PREPARING ACTIVITY Air Force-85 CUSTODIANS ARMY IR NAVY EC AIR FORCE DLA Army-AV Air Force-99 REVIEW DLA-ES USER PROJECT NUMBER 5930-1437-02	MILITARY SPECIFICATION SHEET TITLE SWITCH, TOGGLE, MINIATURE SINGLE POLE, TOGGLE SEAL	SPECIFICATION SHEET NUMBER MS27718E 18 Jun 1990 SUPERSEDING MS27718D 20 May 1988 AMSC N/A FSC 5930
DISTRIBUTION STATEMENT A Approved for public release, distribution is unlimited		Page 1 of 1

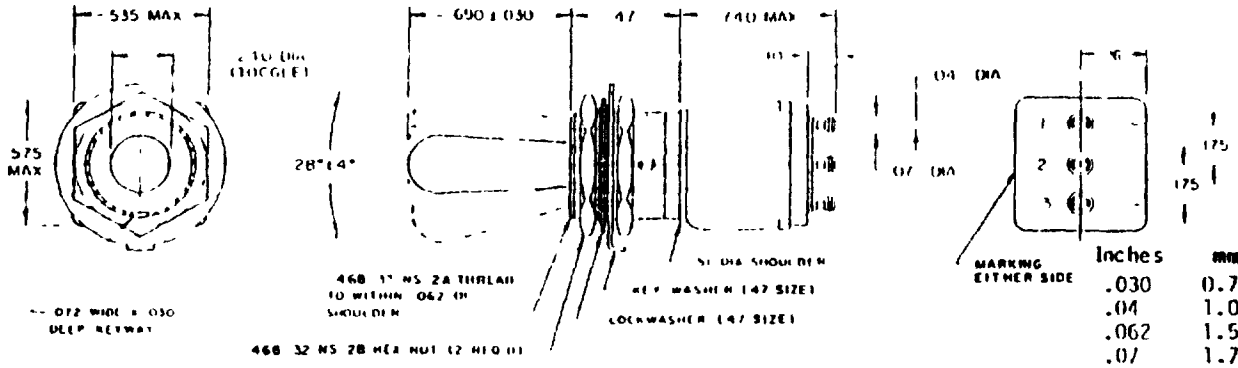
5. Intermediate current shall be performed for 30,000 cycles
6. Terminals shall be molded into the switch case and shall accommodate no 18 awg wire
Ⓔ 7. Maximum weight shall be .025 lb.

Ⓔ denotes changes
